Access Compliance Report Public Rights-of-Way (Curb Ramps)

Main Street: LOS PATRONES PKWY	Cross Street: OSO PKWY	Location: NE
--------------------------------	------------------------	--------------

ADA ID: RPRK211021120833	Ramp Type: Type 1 - Perpendicular Diagonal Initial Pass/Fail: Pass	Overall Compliance: No	Severity Score: 6
--------------------------	--	------------------------	-------------------

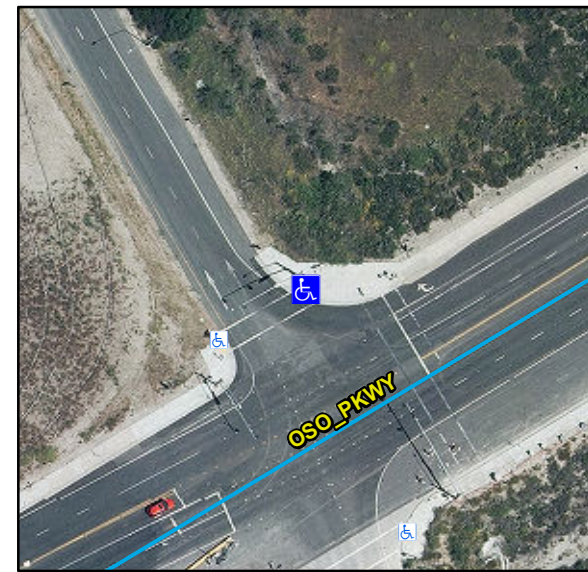
Yes	Ramp Inside Crosswalk 1	Yes	Yes	Ramp Inside Crosswalk 2	N/A
	Crossing 1 Slope (%)	0.4		Crossing 2 Slope (%)	3.5
	Crossing 1 Cross Slope (%)	1.1		Crossing 2 Cross Slope (%)	3.4
Yes	Gutter Ponding	No	Yes	Curb Slope	4.9
Yes	Gutter Lip Height (in)	0		Road Run Slope (%)	1.1
No	Gutter Run Slope (%)	6.1		Road Cross Slope (%)	4.5
Yes	Gutter Cross Slope (%)	1.9			
Yes	Overall Surface Condition: Acceptable		Yes	Perp Joint Present	Yes
	Cross Gutter Present?	No		Spandrel Present?	No
	Replace Cross Gutter?	N/A		Replace Spandrel?	N/A

Remove & Replace Gutter.

R304.5.4, STD 1115
